Playground equipment for children - Part 2: Replies to requests for interpretation of EN 1176:2017 and its parts (2020 -- 2022)

CEN/TR 17842-2

September 2024

Figure 1

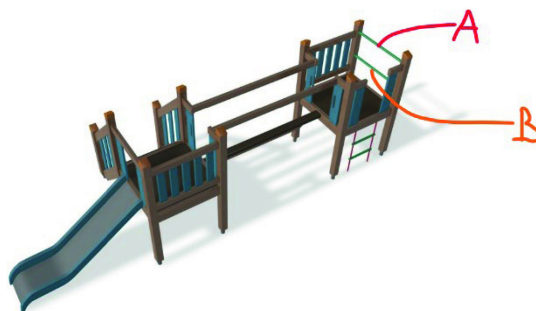
1. Is the underside of a guardrail (A) allowed to have elements or geometries (B) that could be used for climbing? See Figure 1.

2. If geometries that could be used for climbing do exist, should the guard rail be included to falling height?

1. Yes. The requirement to discourage climbing is given only for barriers and not for the guard rails.
2. In line with interpretation 2011-04, only if the guardrail allows access to higher locations, the guard rail is considered a climbing element and should be included to the falling height.

A Guardrail' is defined in EN 1176-1:2017+A1:2023, clause 3.23, as 'rail intended to prevent a user from falling'.

Requirements for 'Guardrails' are given in EN 1176-1:2017+A1:2023, clause 4.2.4.3, which do not require them to discourage climbing.

1. Yes. The requirement to discourage climbing is given only for barriers and not for the guardrails.
2. Yes. Any elements that encourage climbing to higher sections of the equipment should be included in the 'Free Height of Fall'. (EN 1176-1:2017+A1:2023, clause 4.2.8.1, includes examples of what features could encourage climbing 'for roofs, or other features not intended for play'. Guardrails are not specifically mentioned although they would generally be expected as a 'feature not intended for play'.)

The Interpretation Panel also noted that when considering a fall onto a platform that is more than 1m high, the surface of the lower platform shall present the necessary impact attenuating properties, in line with EN 1176-1:2017+A1:2023, clause 4.2.8.5.4.
